REQUEST FOR INFORMATION
No. 00056

TITLE: Cooling Tower C-clips

PROJECT: BNL CCWF-II

SK-1

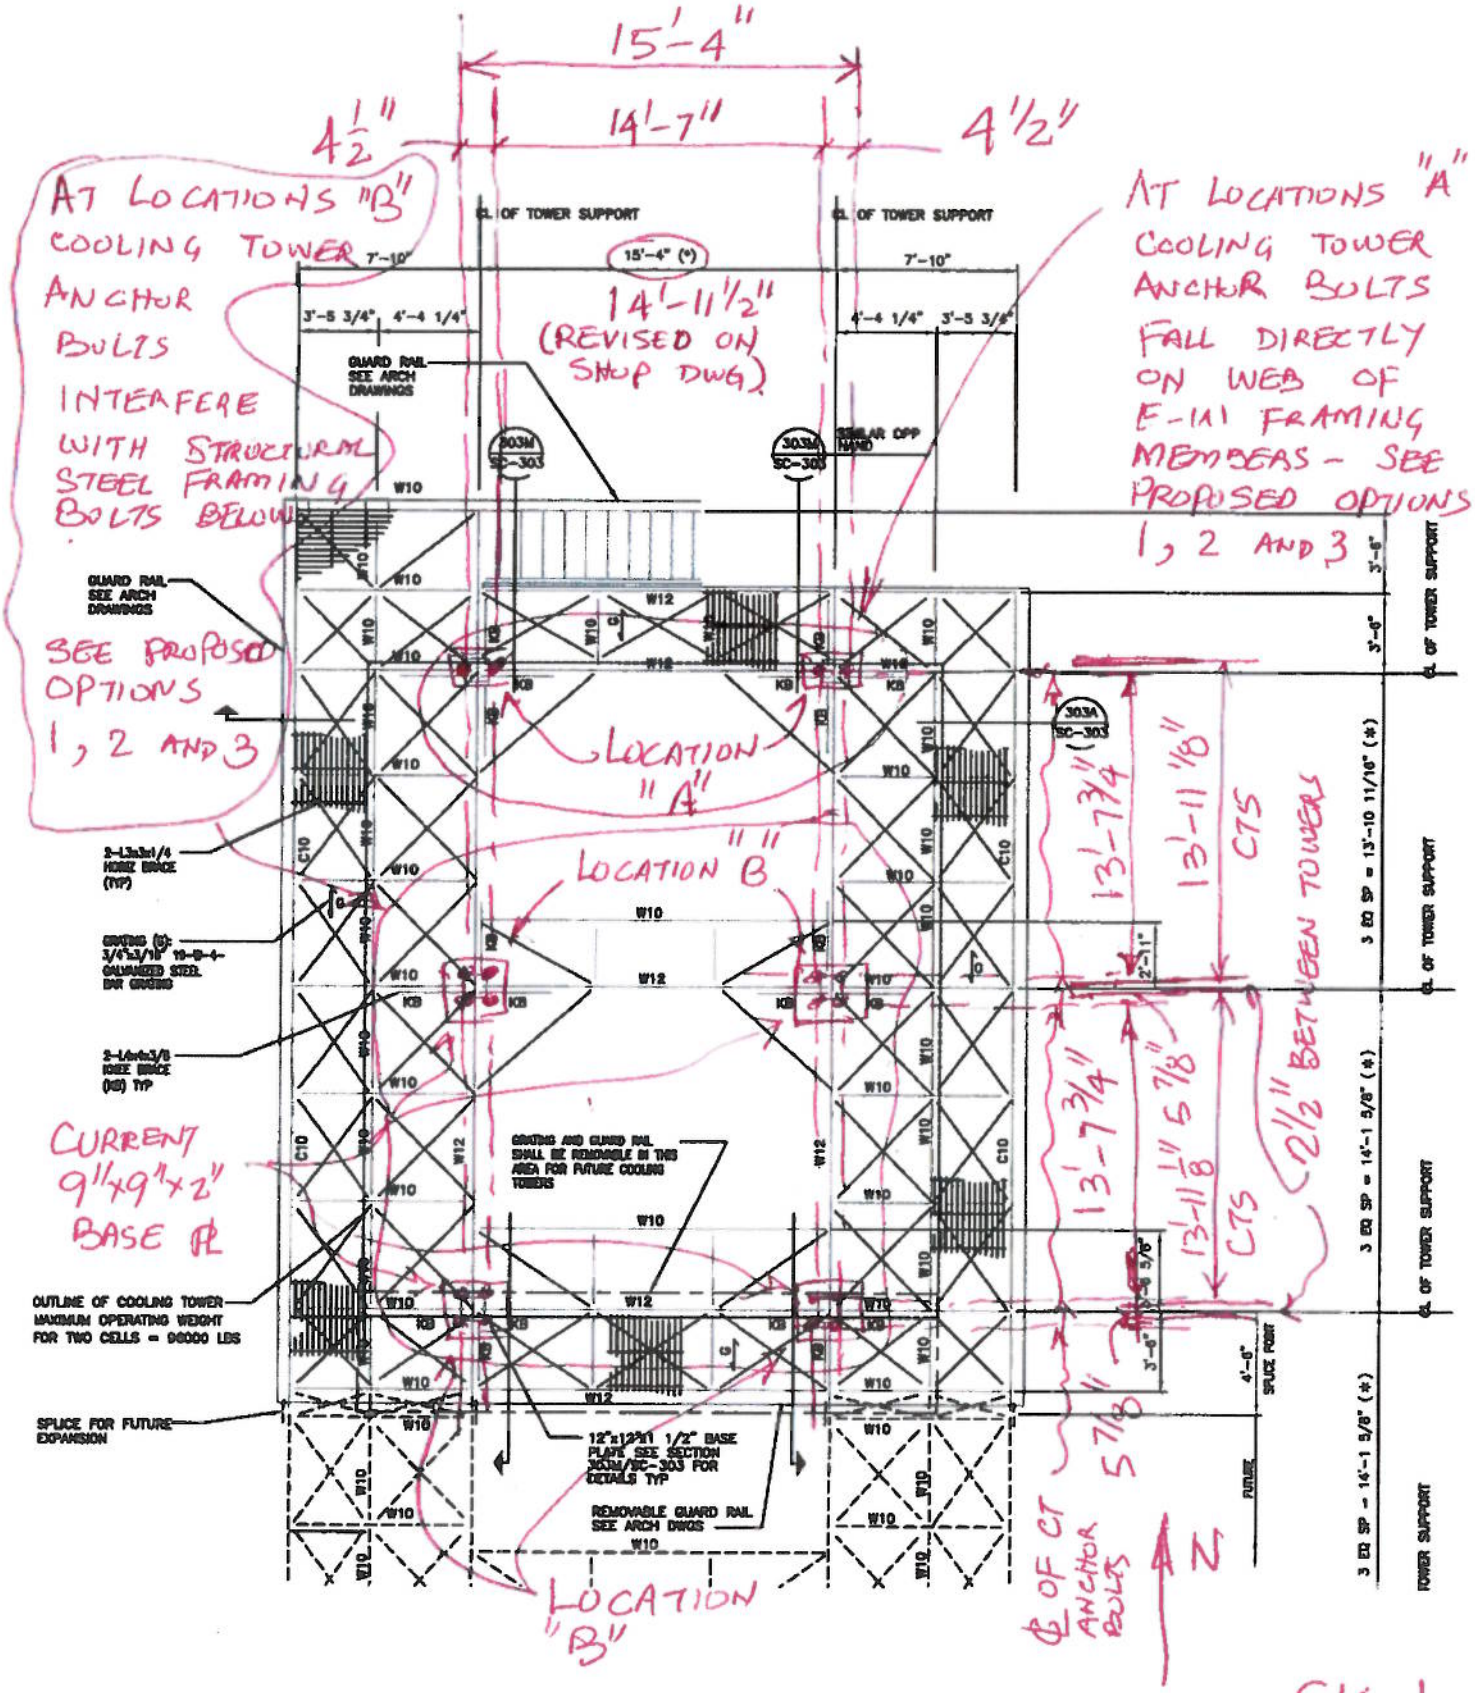
The bolts that connect the cooling tower to the cooling tower platform steel are interfering with the bolts of the structural beams (please see attachment). As a solution we propose to bolt on a C-clips to the bottom of the cooling tower, rig the cooling tower in place and weld on the c-clips to the baseplate. Please advise on sizing of the c-clip.

Proposed option of a C- section is structurally not adequate (need 1 1/4" plate on top to support cooling tower loads over 8" MC-section). Also, the proposed option may not provide adequate space for nut and washer to bear on the web of C-section (3/4" diameter anchor bolts on 4 1/2" x 5 7/8" spacings to fit inside an MC8). Contractor pointed to anchor bolt interference at the intermediate locations between the towers. However, I also discovered, for CT5, at the north-east and north-west corners, the anchor bolts fall directly on the web of the framing members

Attached sketches SK-1 to SK-5 identify these situations and the proposed options 1 to 3, for considerations by all. Selected option must be agreed upon by the cooling tower manufacturer.
